UNITED STATES PATENT AND TRADEMARK OFFICE

Office Action Summary

10/789,258

DETAILED ACTION

FIG. 18

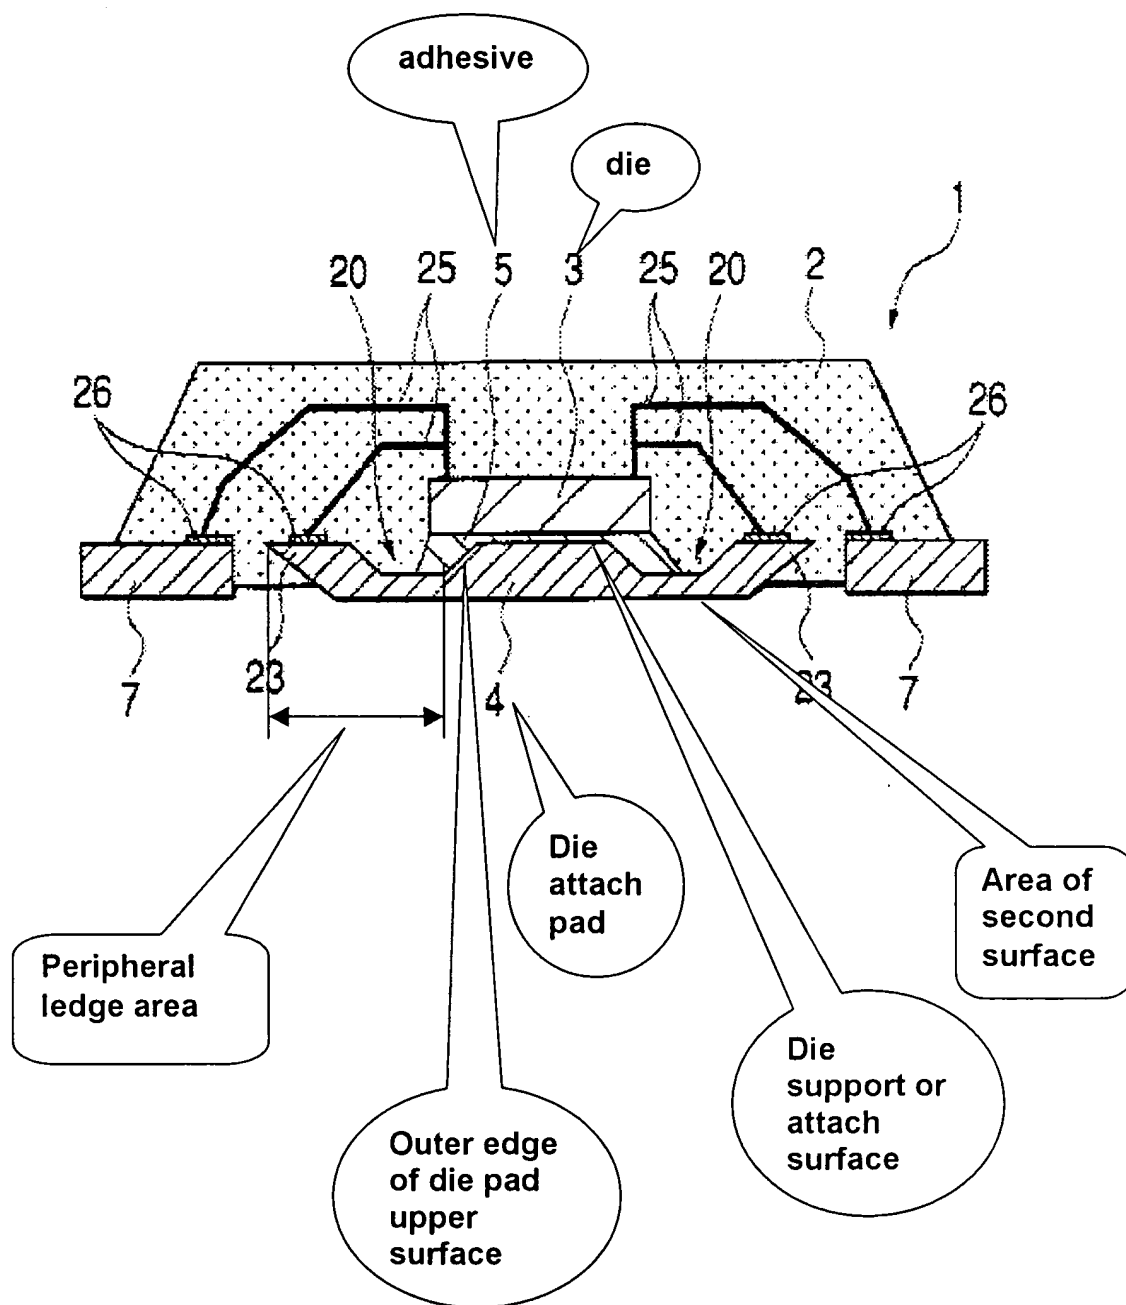
Regarding claims 2 and 9, Hasebe (Figs. 8 and 18) discloses a substrate panel for use in semiconductor packaging, the substrate panel comprising:

a lead frame panel 40 including a plurality of device areas 41 (Fig. 8, column 10, lines 65-67 and column 11, line 1), each device area 41 having a die attach pad 4 and a plurality of contacts 7, wherein each die attach pad 4 includes a die support surface and a peripheral ledge that is defined as a peripheral portion which extends laterally from the bottom surface of the recess 20 to the tip portion 23 (See Fig. 18 labeled by the examiner below), the peripheral ledge is recessed relative to the die support surface, wherein the peripheral ledges extend around the outer edges of the die attach pads 4; and

a plurality of semiconductor dies (see Fig. 8), each die 3 being attached to the die support surface of an associated die attach pad 4 using an adhesive 5 (Fig. 18 labeled by the examiner below), wherein a portion of each semiconductor die 3 extends beyond an outer edge of its associated die attach pad 4, and wherein the ledge is configured to retain an amount of the adhesive 5 (Fig. 18 labeled by the examiner below and column 12, lines 26-36).

a lead frame panel 40 including a plurality of device areas 41 (Fig. 8, column 10, lines 65-67 and column 11, line 1), each device area 41 having a plurality of contacts arranged around a die attach pad 4, wherein each die attach pad 4 includes a die support surface and a recessed ledge that is defined as a peripheral portion which extends laterally from the bottom surface of the recess 20 to the tip portion 23 (See Fig. 18 labeled by the examiner below), the recessed ledge has recessed bottom surface 20 being lower than the die support surface and extends along an edge of the die attach pad 4 (also see Fig. 19).

Regarding claims 3 and 10, Hasebe discloses that each die attach pad 4 has a second surface opposite to the die attach surface, wherein the area of the die attach surface is less than the area of the second surface (See Fig. 18 labeled by the examiner above).

Regarding claims 4 and 11, Hasebe (Fig. 18) discloses that bottom surfaces of the contacts 7 are substantially co-planar with bottom surfaces of the die attach pads 4.

Regarding claims 6 and 13, Hasebe discloses that the semiconductor dies 3 are down bonded to the respective ledges of their associated die attach pads 4 (Fig. 18 labeled by the examiner above).

Regarding claim 17, Hasebe discloses that the peripheral ledge extend entirely around the outer edge of the die attach pads (See Fig. 18 above).

Regarding claim 18, Hasebe discloses that a plurality of semiconductor dies are attached to the die support surface of each die attach pad 4 using an adhesive layer 5, wherein a portion of each semiconductor die 3 extends beyond an outer edge of its associated the die attach pad 4, wherein the ledge is configured to retain an amount of the adhesive 5 (See Fig. 18 above and column 12, lines 26-36).

5. Applicant argues that a groove 20 of Hasebe is not “a peripheral ledge” as claimed (claims 2 and 9) because the groove 20 is interior from the edge of the die attach pad and does not extend to the edge of the die attach pad.

This argument is not persuasive because the groove 20 is not relied on for teaching “a peripheral ledge” as asserted by Applicant, but rather, “a peripheral ledge” in Hasabe’s Fig. 18 is defined as a peripheral portion which extends laterally from the bottom surface of the recess 20 to the tip portion 23 (See Fig. 18 labeled by the examiner on page 5). Clearly, the above defined peripheral ledge is formed at outer boundary of the die attach pad and extends to the edge of the die attach pad.

Therefore, Fig. 18 of Hasebe does disclose “a peripheral ledge” as claimed in claims 2 and 9.

This argument is not persuasive because Fig. 18 of Hasebe does suggest all the limitations recited in the above new claims, including the limitations of having each die attach pad 4 includes a die support surface and a recessed ledge that is defined as a peripheral portion which extends laterally from the bottom surface of the recess 20 to the tip portion 23, the recessed ledge has recessed bottom surface 20 being lower than the die support surface and extends along an edge of the die attach pad 4 (See ground of refection for more details).
